Project	IEEE 802.16 Broadband Wireless Access Working Group < http://ieee802.org/16 >	
Title	Corrections to definitions of Uplink MIMO in OFDMA PHY	
Date Submitted	2004-11-13	
Source(s)	Ran Yaniv, Tal Kaitz, Naftali Chayat, Vladimir Yanover Alvarion Ltd.	ran.yaniv@alvarion.com tal.kaitz@alvarion.com
Re:	Call for comments, maintenance task group	
Abstract		
Purpose		
Notice	This document has been prepared to assist IEEE 802.16. It is offered as a basis for discussion and is not binding on the contributing individual(s) or organization(s). The material in this document is subject to change in form and content after further study. The contributor(s) reserve(s) the right to add, amend or withdraw material contained herein.	
Release	The contributor grants a free, irrevocable license to the IEEE to incorporate material contained in this contribution, and any modifications thereof, in the creation of an IEEE Standards publication; to copyright in the IEEE's name any IEEE Standards publication even though it may include portions of this contribution; and at the IEEE's sole discretion to permit others to reproduce in whole or in part the resulting IEEE Standards publication. The contributor

Figure 249—UL STC tile

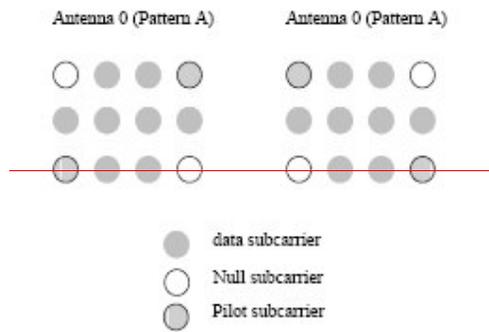
A user supporting transmission using STC configuration in the uplink, shall use a modified uplink tile. 2-transmit diversity ('STTD mode') data or 2-transmit spatial multiplexing ('SM mode') data can be mapped onto each subcarrier. The mandatory tile shall be modified to ~~accommodate~~ accommodate those configurations. [Figure 249 depicts the UL tile for STC transmission.](#)

Figure 249 – Mapping of data subcarriers in STTD mode.

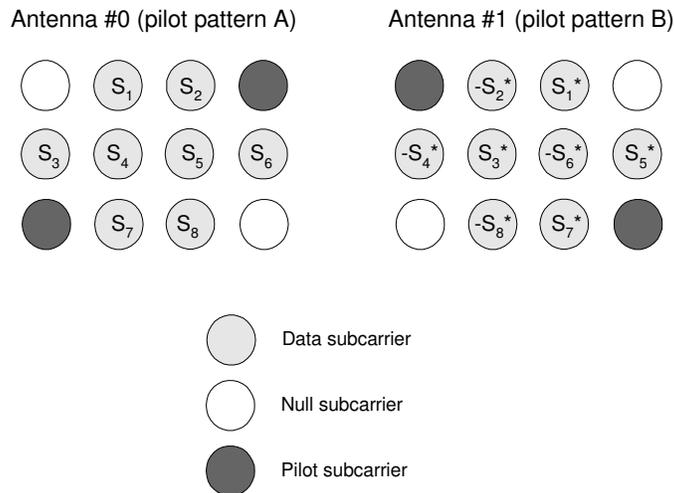
1. The data-subcarrier mapping scheme for UL STTD is not defined (8.4.8.1.5). Note that encoding subcarrier pairs across multiple tiles is not possible due to the existence of the subchannel rotation scheme.

1. Correct section 8.4.8.1.5: provide missing definition of STTD mode, define data subcarrier mapping in STTD mode.

[In STTD mode, the tiles shall be allocated to subchannels and the data subcarriers enumerated as defined in 8.4.6.2. The pilots in each tile shall be split between the two antennas and the data subcarriers shall be encoded in pairs after constellation mapping, as depicted in figure 249. The data subcarriers transmitted from Antenna #0 follow the original mapping defined in 8.4.6.2.](#)
